# STAFF RECOMMENDATION

**NCPC File No. ZC 07-21**

## CONSOLIDATED PLANNED UNIT DEVELOPMENT, 2201 M STREET, NW SQUARE 50, LOTS 82, 84, 813, 816

April 24, 2008

**Roof Plan**

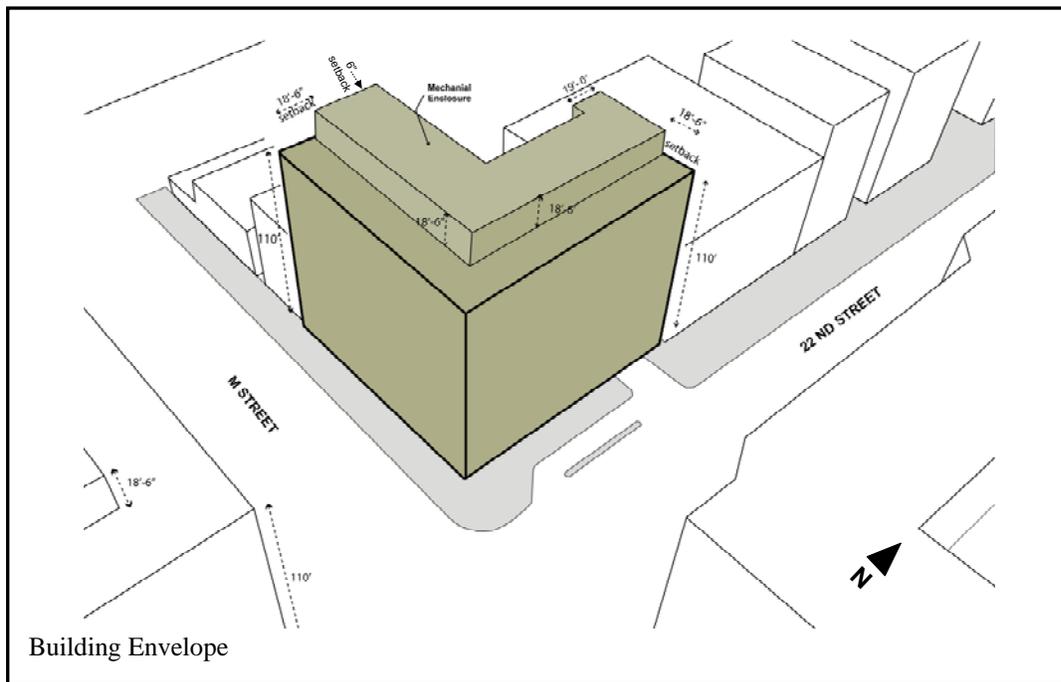
As the roof plan shows, there are three proposed penthouses. Penthouse A on the southwest corner of the building encloses the air handling units and emergency generator, and has a height

of 18 feet 6 inches above the roof. It is properly setback 18 feet 6 inches from the south exterior wall along M Street, but only six inches from the west exterior wall, adjacent to another building on M Street that is approximately 45 feet in height. It is also only setback 6 feet from the north exterior wall that faces the court. Penthouse B, which encloses the passenger elevator, elevator lobby, restrooms, seasonal outdoor bar and covered area, has a height of 18 feet, 6 inches and is properly set back 18 feet 6 inches from the south exterior wall along M Street and the east exterior wall along 22<sup>nd</sup> Street; however, it is not setback from the north and west exterior walls facing the court. Finally, Penthouse C, which is located along 22<sup>nd</sup> Street on the northeast corner of the building, encloses the chiller and cooling towers, and has a height of 18 feet 6 inches above the adjacent roof. It is properly set back 18 feet 6 inches from the east exterior wall along 22<sup>nd</sup> Street, but is not set back from the north exterior wall which abuts another building fronting 22<sup>nd</sup> Street that is approximately 55 feet tall. It is also only setback 6 feet from the west exterior wall facing the court. The roofs of the penthouses have solar hot water panels that will heat water for the building.

**Staff also recommends that the Commission recommend** that the Zoning Commission require the applicant to modify the project design to set back the penthouses a distance from all exterior walls of the building equal to their respective heights above the adjacent roof.

Building Envelope

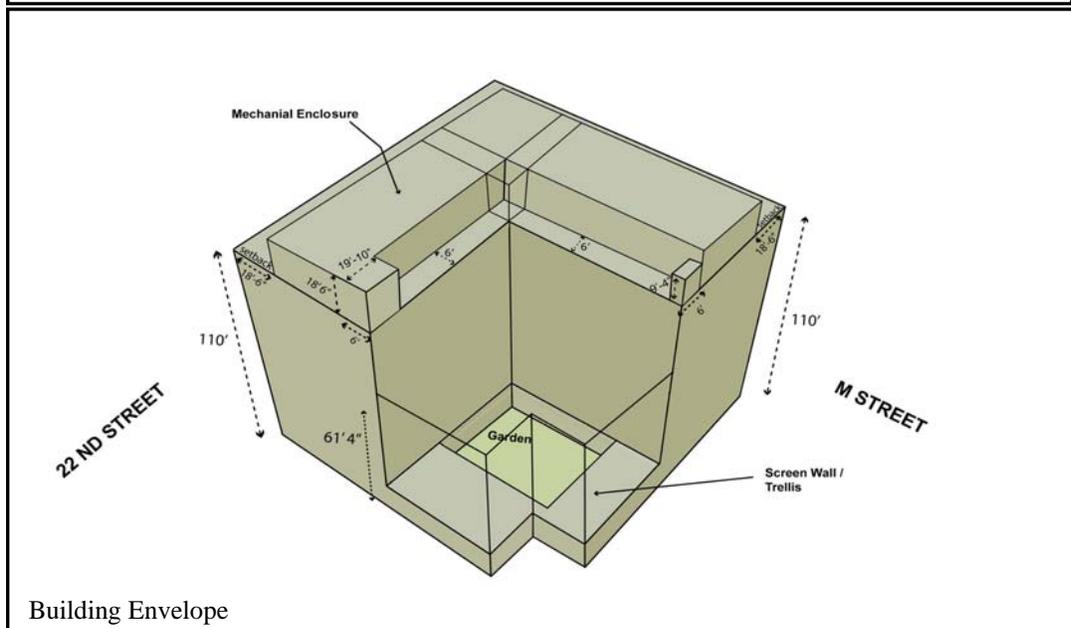
Therefore both the north and west walls which abut the court and the north and west walls which abut adjacent buildings are exterior walls since they are all exposed to the weather. It is important to look at these two issues separately and in more detail.

Building Envelope

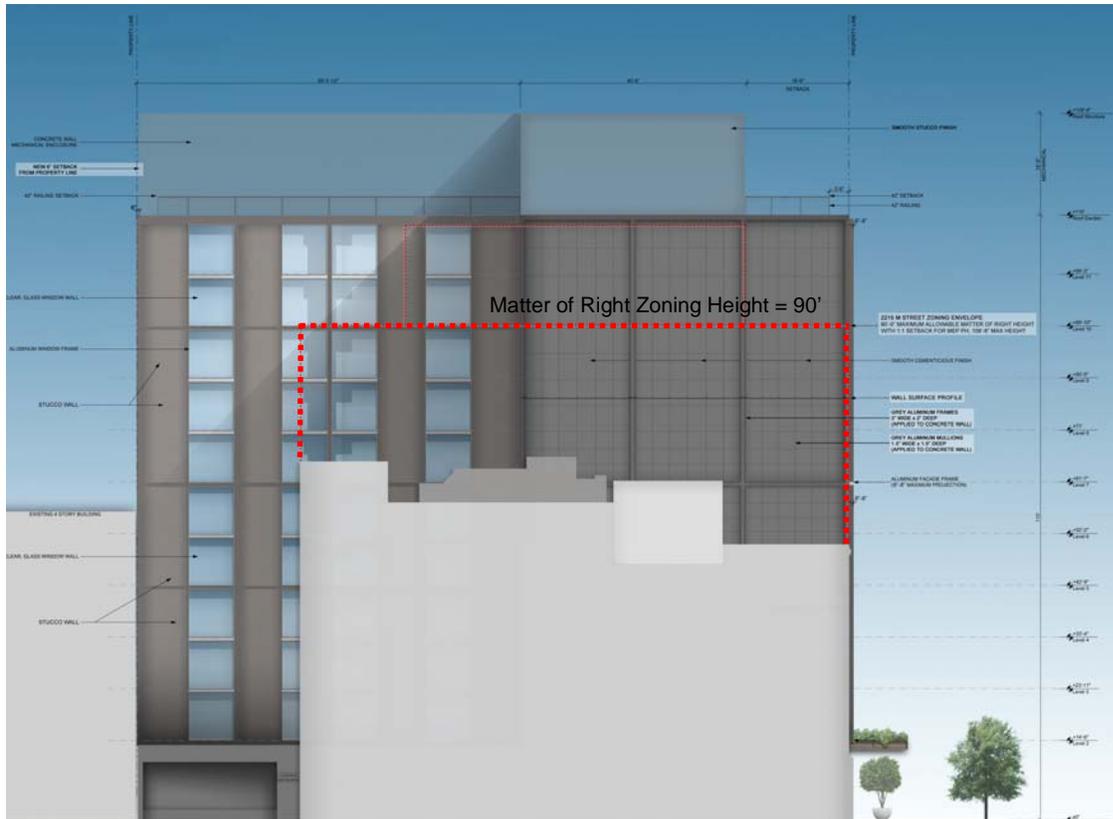
The walls that face the court are clearly exterior walls since they are not adjacent to any other properties in which a building could be built and will therefore always remain exposed to the weather. The applicant has acknowledged that these are exterior walls and has sought relief from the Zoning Commission from the setback requirement. The definition of “court” in the Zoning Code also supports that these walls are exterior. It defines a “court” as an unoccupied space open to the sky, on the same lot with a building which is bounded on two (2) or more sides by the exterior walls of the building or by (2) or more exterior walls, lot lines, or yards.

Staff finds that the north and west walls that abut the adjacent buildings on M and 22<sup>nd</sup> Streets are also exterior walls. The matter of right height is 90 feet for the properties to the north and west of the proposed building. The developer stated in Exhibit No. 48 to the Zoning Commission dated March 24, 2008 that this height, in addition to the maximum allowable penthouse at 18.5 feet, would result in the adjoining north and west walls to be classified as “party walls” because they would be approximately the same allowable height of the proposed building at 110 feet. Staff agrees with the developer that the allowable height limit under zoning is 90 feet for these properties and therefore portions of these walls will always be exposed to the weather. Furthermore, staff finds that the location, position and size of potential penthouses on the adjacent roof properties will vary and can not be assumed as the developer has presented.

**Therefore staff recommends** that the north and west elevations of the proposed building would be exposed to the weather, given the 90 foot matter of right height limit, and must be considered exterior walls. The following two elevations show the matter of right height for the two adjacent properties to the west and north.
